## CUBBIE ROO'S CASTLE / ST MARY'S CHURCH - INTERPRETATION PLAN

**CUB1** – 420x594mm, wall-mounted. Remove old metal panel on opposite side of wall.

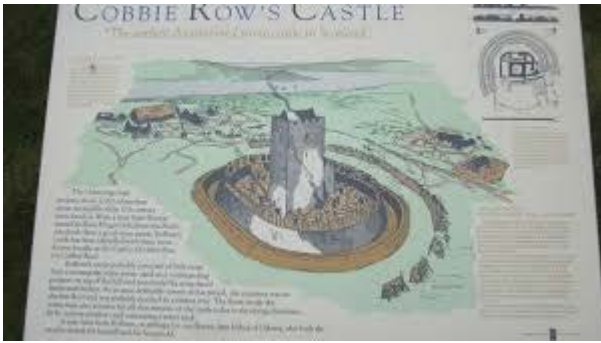
CNR: the present panel is of limited use for visitors, who will generally encounter it only on their exit from the monument. Removing it and installing a new panel on the opposite side of the wall will offer a better welcome to visitors. It will also enable useful visitor management messages to be provided early in the visit. Fixings will be into joints and so will have limited impact on the fabric of the monument. The design will also be in accordance with HS Interpretation Unit house style and so will insure the panel will be visually discreet. Its visual impact will therefore also be minimal.
